**NOTICE OF ADDENDUM
ADDENDUM NO. 2**

**CONTRACT NO. 7939
MADISON MUNICIPAL BUILDING - RENOVATION**

This addendum is issued to modify, explain or correct the original Drawings, Specifications, or Contract Documents and is hereby made a part of the contract documents.

**EXHIBIT E
 A301**

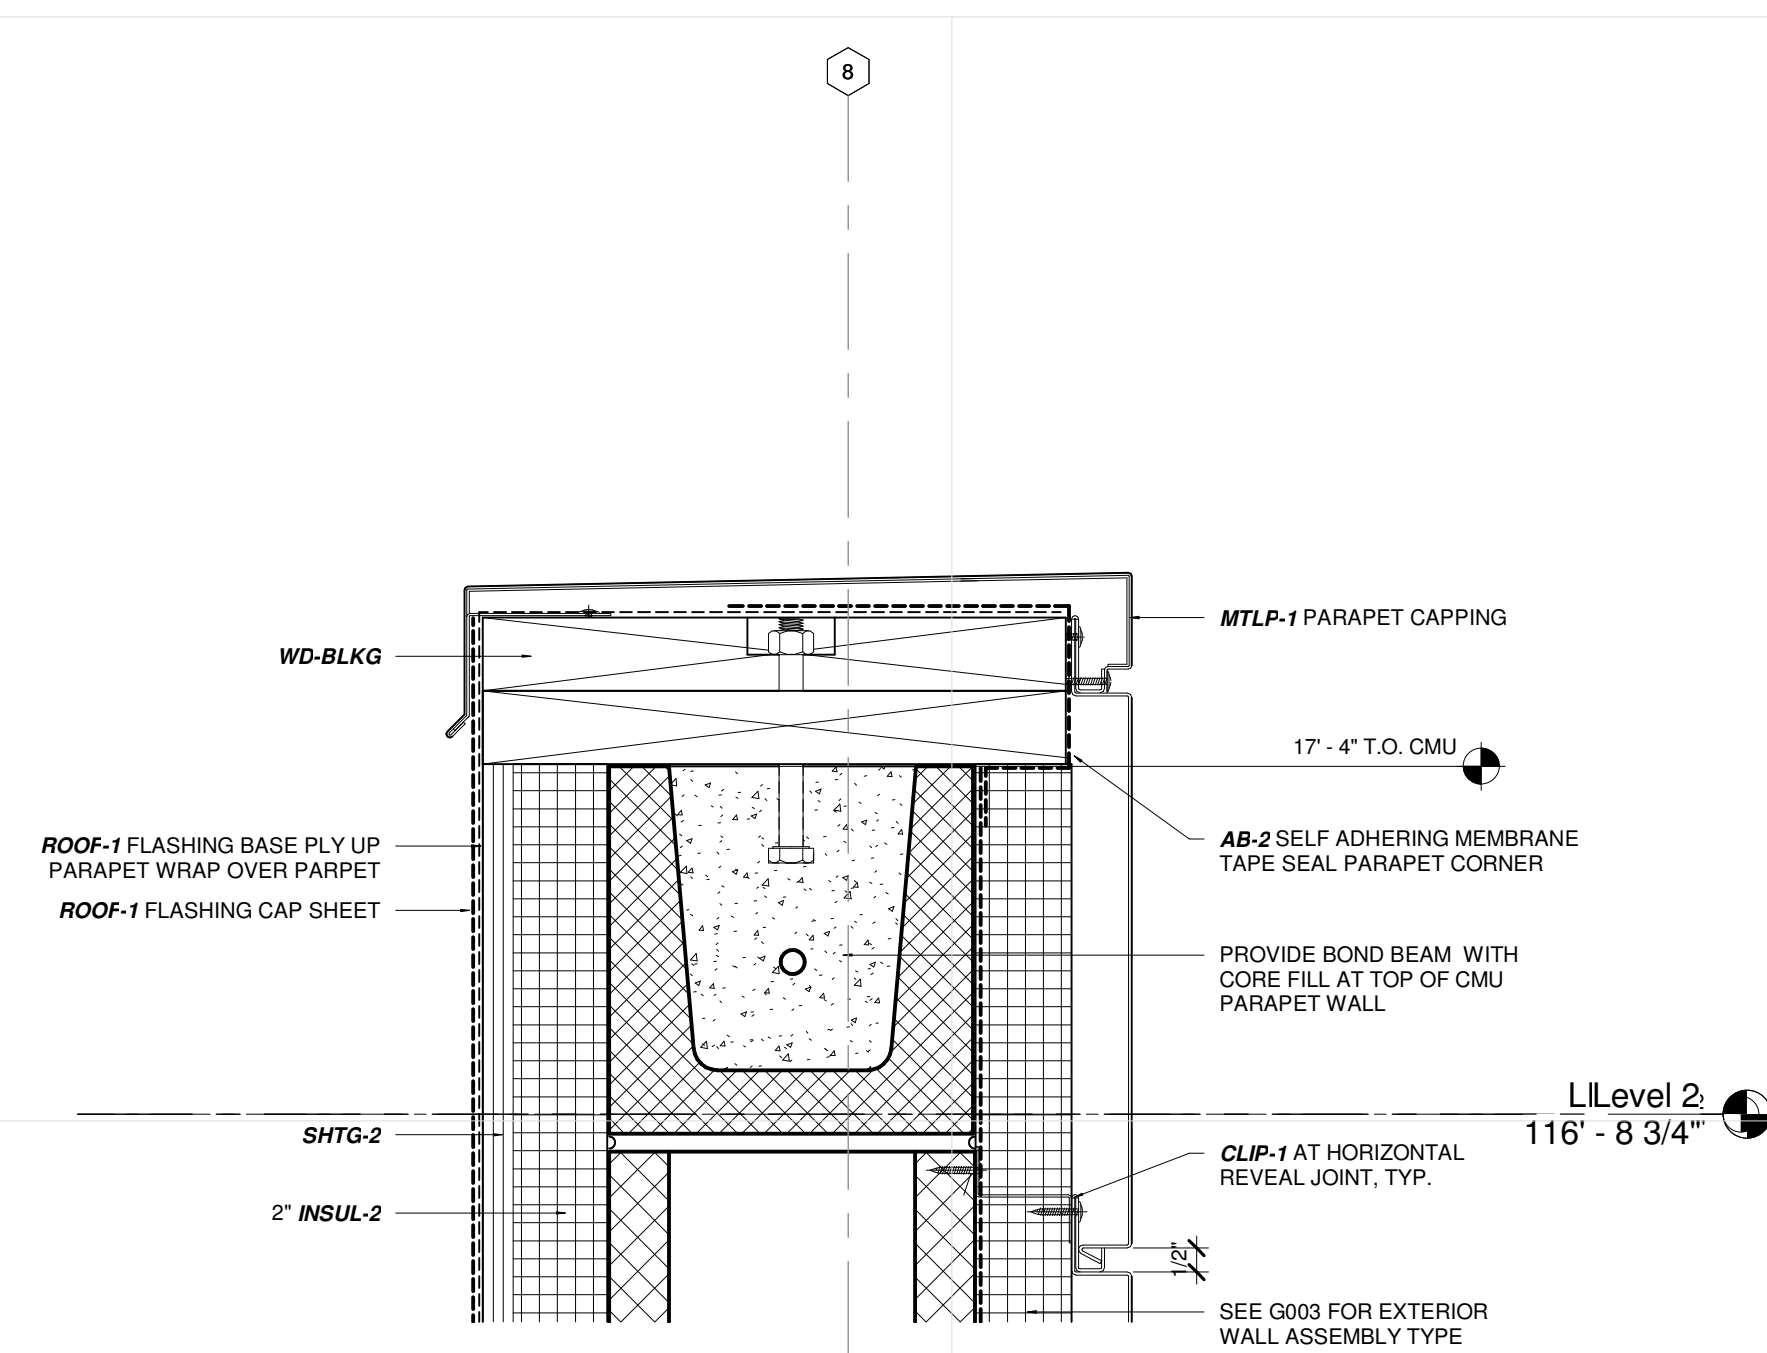
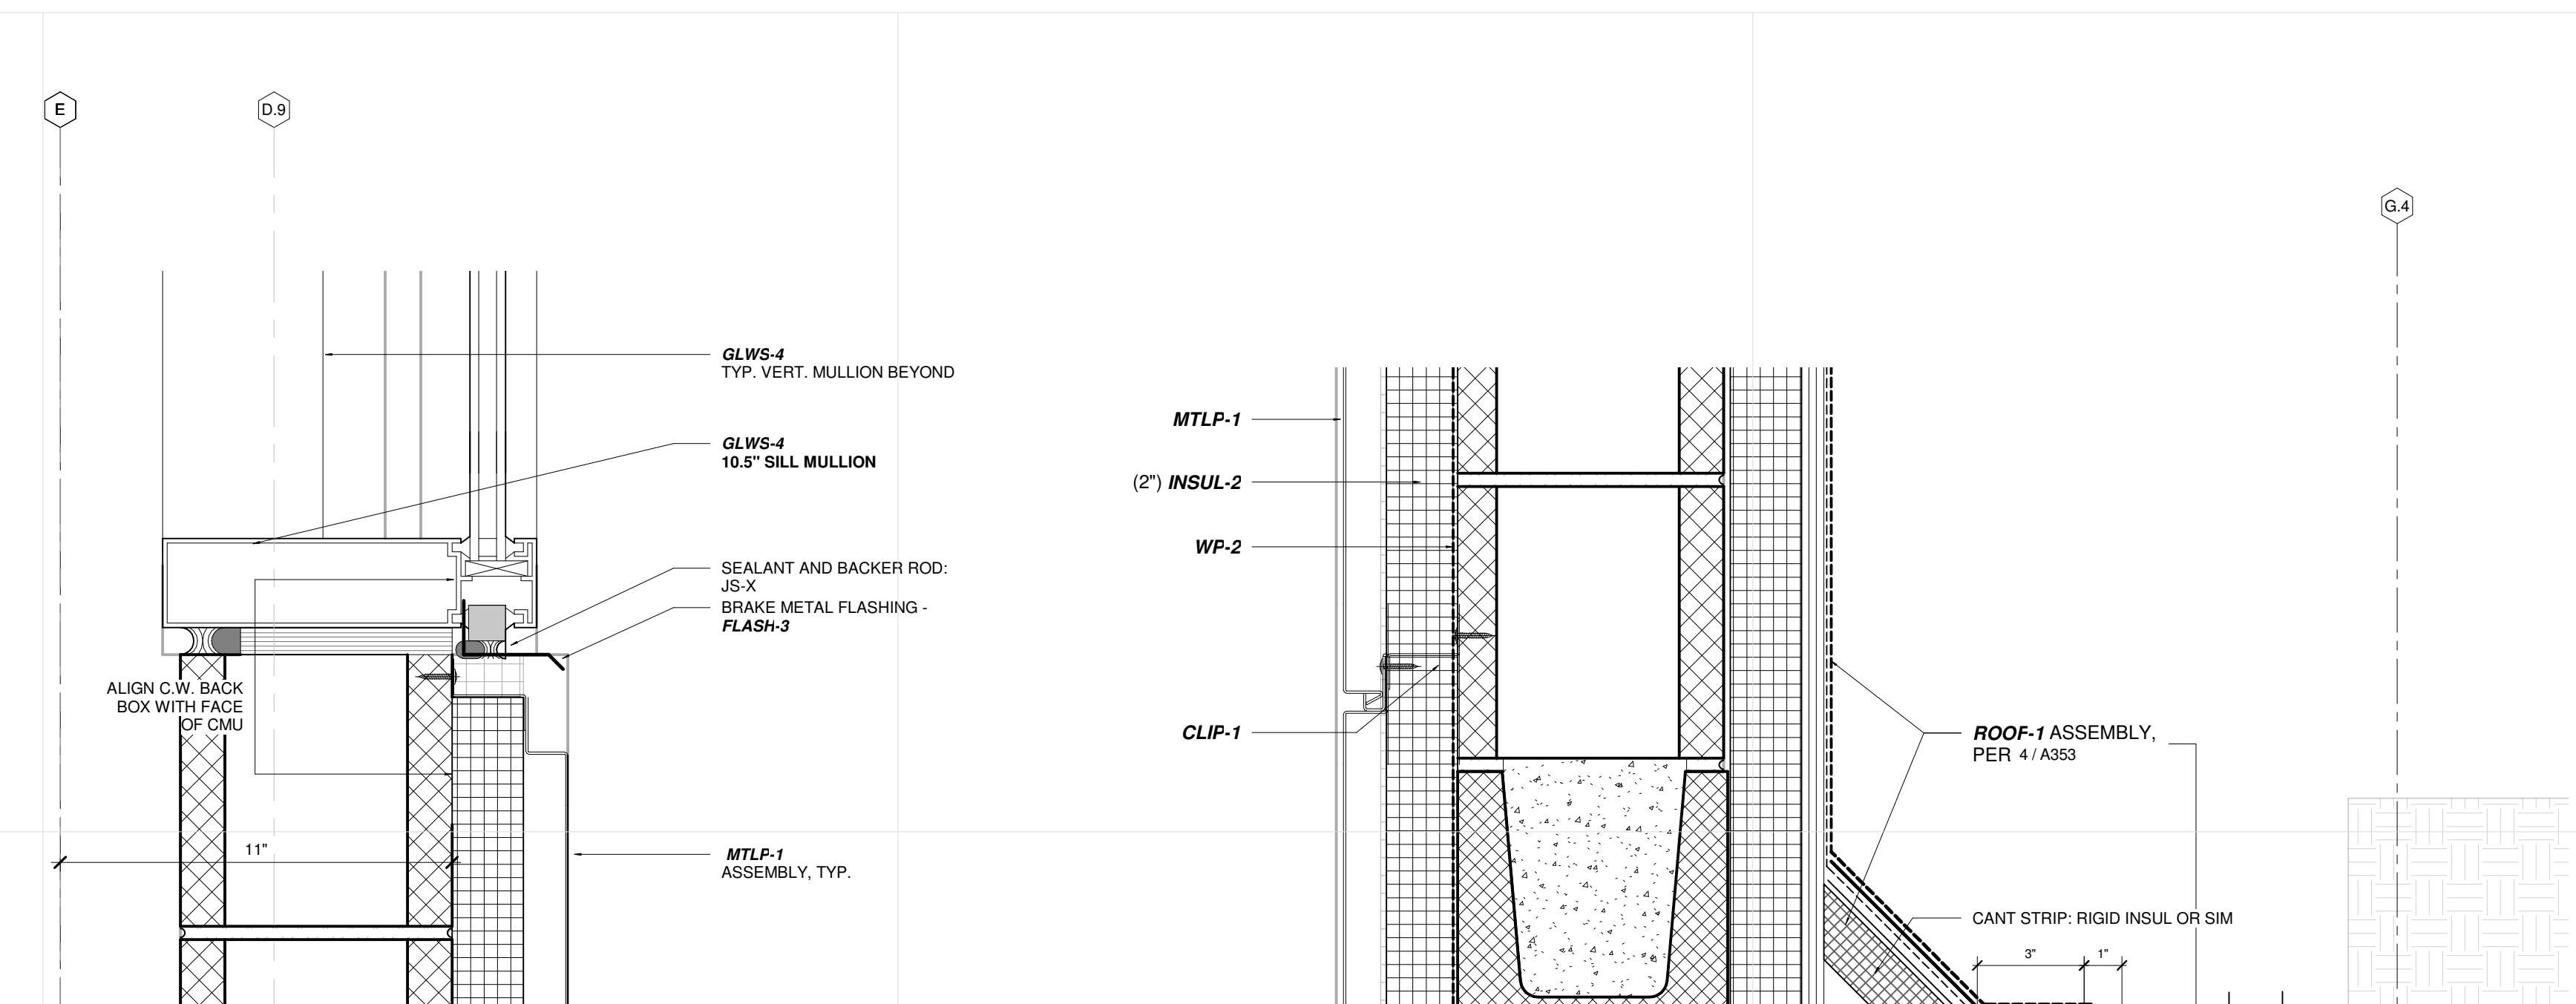
1. Detail 1/A192 Revised to center vestibule on exterior doors.
2. Details 7 and 8/A301. Revised details to clarify waterproofing notes.
3. Details 5,7 and 9/A353. Revised details to clarify waterproofing notes.

Answer: Yes.
11. **Question:** Sheet A301 shows elevations for the new North addition. Please answer the following questions.
Answer: See revised sheet A301 and A353 issued with this addendum. Also, refer to details called out on A301 for additional information on details.
